Access Compliance Report

Public Rights-of-Way

(Curb Ramps)

Intersection ID: 48714	Main Street: SARDIS_CREEK_LN	Cross Street: KILCULLEN_DR	Location: NW
ADA ID: 3ABB2053AACC	Ramp Type: PerpDiag	Initial Pass/Fail: Fail	Overall Compliance: No
			Severity Score: 21.25

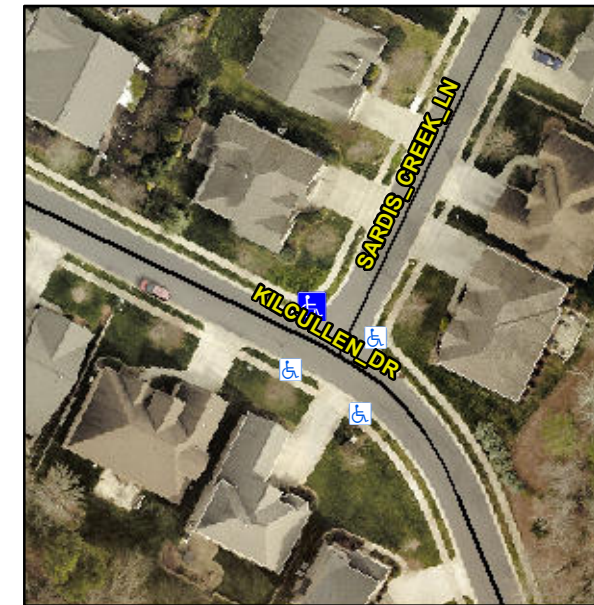
R304.5.1, R304.2.2

Compliance	Description	Data	Compliance	Description	Data
N/A	Ramp Length (in)	51.0	No	Ramp Slope (%)	9.2
No	Ramp Width (in)	47.0	Yes	Ramp XSlope (%)	0.3
N/A	Flare Type LT	N/A	N/A	Flare Type RT	N/A
N/A	Flare Slope LT (%)	N/A	N/A	Flare Slope RT (%)	N/A
N/A	Flare Traversable LT?	N/A	N/A	Flare Traversable RT?	N/A
N/A	Landing Length (in)	N/A	N/A	DWS Provided?	N/A
N/A	Landing Width (in)	N/A	N/A	DWS Contrast?	N/A
N/A	Landing Slope (%)	N/A	N/A	DWS Length (in)	N/A
N/A	Landing X Slope (%)	N/A	N/A	DWS Full Width?	N/A
N/A	Landing Curb? (Y/N)	N/A	N/A	DWS Offset (in)	N/A
N/A	Shared Landing?	N/A			
N/A	Gutter Ponding?	N/A	N/A	Gutter Slope (%)	N/A
N/A	Gutter Lip Ht (in)	N/A	N/A	Gutter X Slope (%)	N/A
N/A	Painted X Walk1?	No	N/A	Painted X Walk2?	No
	X Walk 1 Direction	To SW		X Walk 2 Direction	To SE
N/A	X Walk 1 Width (in)	N/A	N/A	X Walk 2 Width (in)	N/A
	X Walk 1 Slope (%)	2.3		X Walk 2 Slope (%)	4.2
	X Walk 1 X Slope (%)	3.0		X Walk 2 X Slope (%)	2.5

Remove & Replace Curb Ramp With Two New Directional Ramps or Equivalent.
